CITY OF <i>Lindsay</i> DEPARTMENT OF PUBLIC WORKS		LOCAL & COLLECTOR STREETS			
MARK	DATE	REVISION	Engineering Standard		
			Approved <i>[Signature]</i>		ST-1A
			Date <i>9/19/79</i>

City of Lindsay Development Standard Addendum May 2006

Development Standard No. ST-6, Barrier Type Curb and Gutter.

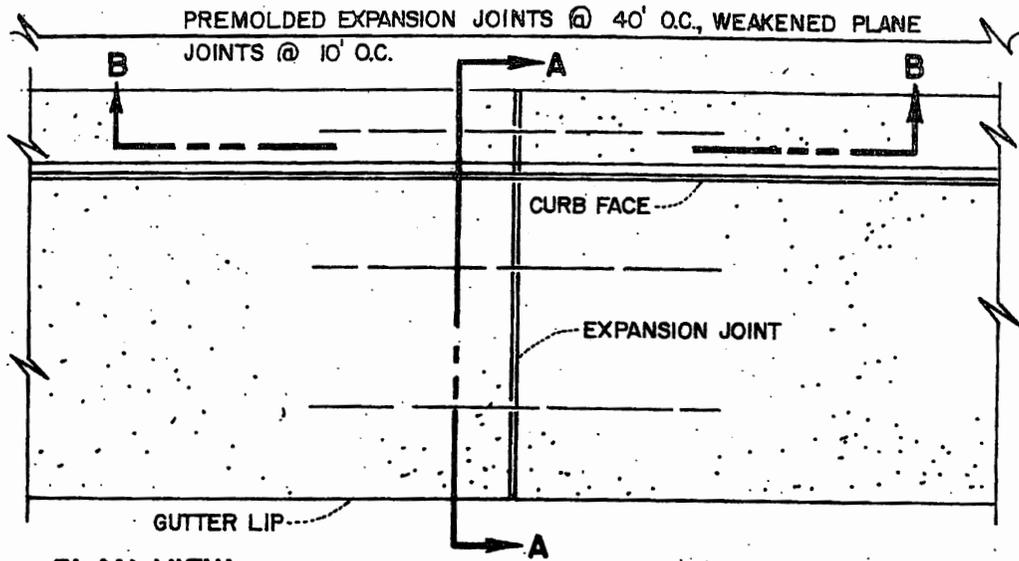
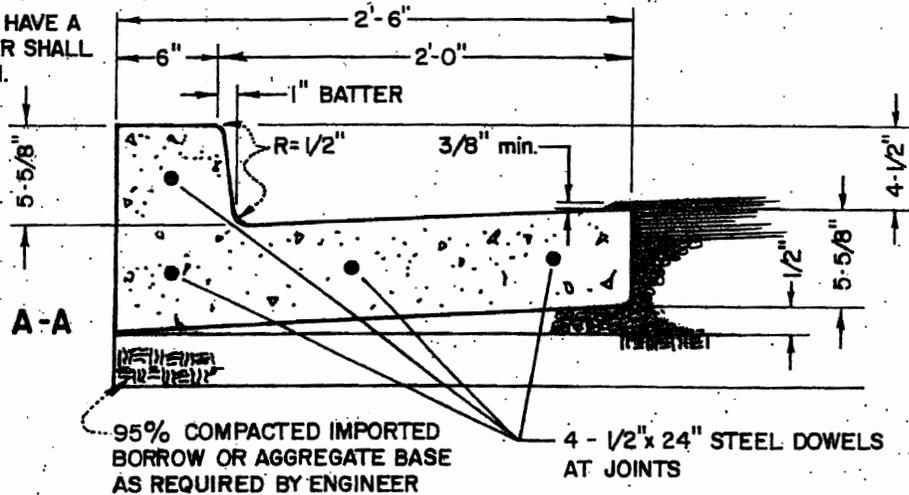
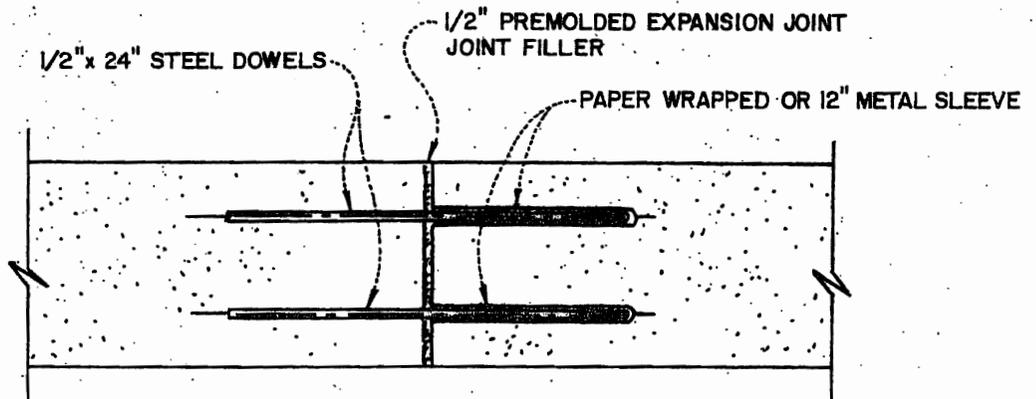
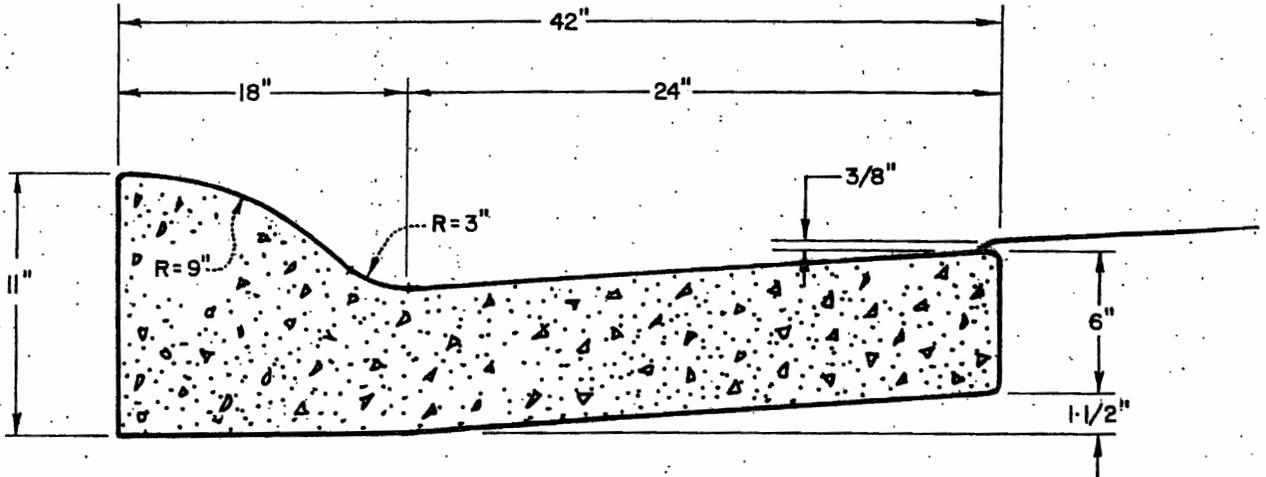
The following items shall be considered City of Lindsay acceptable construction practice and allowed for the construction of curb and gutter.

This applies to machine pour curb and gutter only. Allowances can be made for form and stake curb and gutter, but will be reviewed on a project by project basis.

- Steel dowels are required at cold joints only. $\frac{1}{2}$ " diameter x 24" long embedded 12" into each section of curb and gutter. A total of 4 dowels (2 in curbing, 2 in gutter pan) are required. Expansion felt shall be required at cold joints also.
- Weakened plane joints (deep joints) shall be required at 20' o.c.; the definition of weakened plane joints shall be 1" minimum depth and shall be finished with a scoring tool leaving the edges rounded.
- "Beauty Mark" joints (surface joints) shall be required at 10' o.c.
- Expansion felt may be omitted from each driveway location as directed by the City representative.
- "0" (zero) lip is required at all handicap curb depressions.
- $\frac{1}{2}$ " lip, maximum, is required at all driveway depressions.
